osmo-clock-gen - Feature #3905

allow user to supply different output voltage

- File clockgen-VDDIO.png added

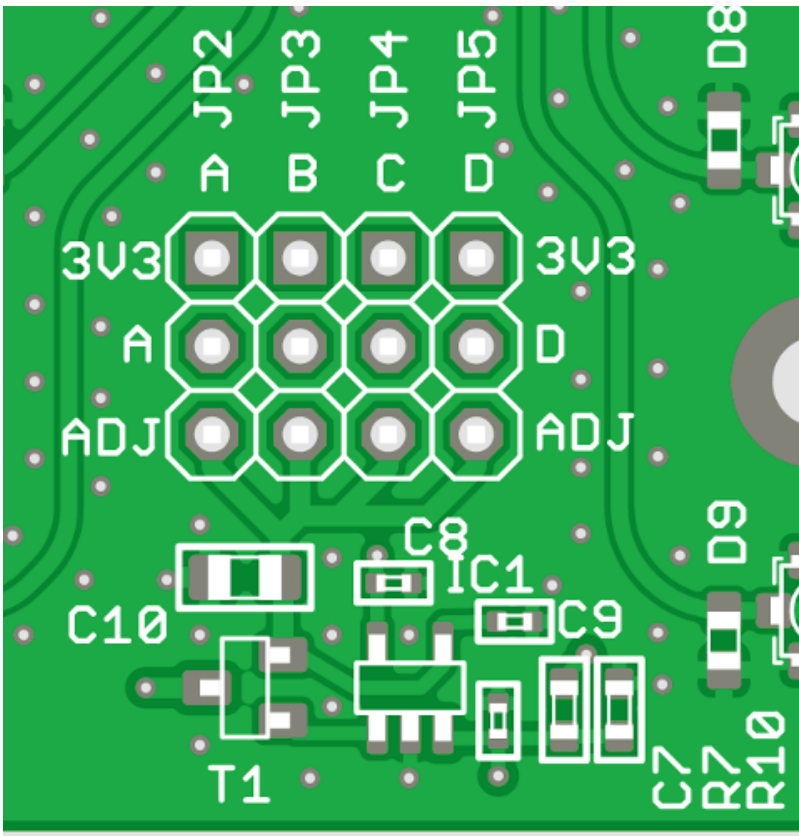
please make sure to keep the ticket updated. latest idea here was to

- have jumpers in-line of two of the four output banks of the PLL chipc
- jumper closed: reference is drawn from one (shared) "other voltage" LDO onboard
- jumper open: reference voltage can be provided/injected by user from external reference

What's still open to discuss is whether or not the LDO will be fixed (you have to change resistors to change the voltage) or adjustable. In the latter case, we'd apply the DAC output of the SAMD21 as an input to the tracking input of the LDO. However, this would mean that we'd no longer have the DAC output for driving a VCTCXO.

after discussion on the RFC mail from laforge, a single R2R / single supply / unity gain stable opamp w/ BJT follower was selected. This buffer stage gets its input voltage from PA02 (VOUT, formerly used for the trim voltage for VCTCXO). A 3 by 4 jumper block allows each PLL's VDDIO{A..D} to be jumpered to fixed 3V3 or the adjustable voltage.

The buffer stage has a weak PD (suggested 100k) on it's input to avoid spikes during power-on as long as the Cortex is not initialized (and e.g. a 1V8 sink is connected). This should not be needed as PULLEN bit is 0 at reset.

I'm aware that this forms a voltage divider together with the input wire's resistance.
